Product Change Notification

PCN Number: FA18060001

Previous Part Number
FR05-S1-N-0-110

New Part Number
NN01-110

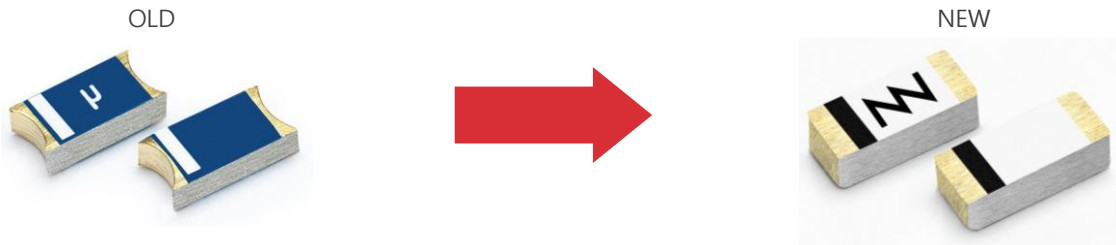
- 1.- Part Number: From FR05-S1-N-0-110 FRACTUS to NN01-110 FRACTUS ANTENNAS in the User Manual
- 2.- Pads-END: From circular to rectangular
- 3.- Color: From blue/white to white/black

- 1.- The color and the logo are different
- 2.- The pads-end of the antenna from circular to rectangular

- 1.- Foot print in the PCB to solder the chip antenna remains the same
- 2.- The matching network to properly tune the chip antenna has to be reviewed and validated. It could change
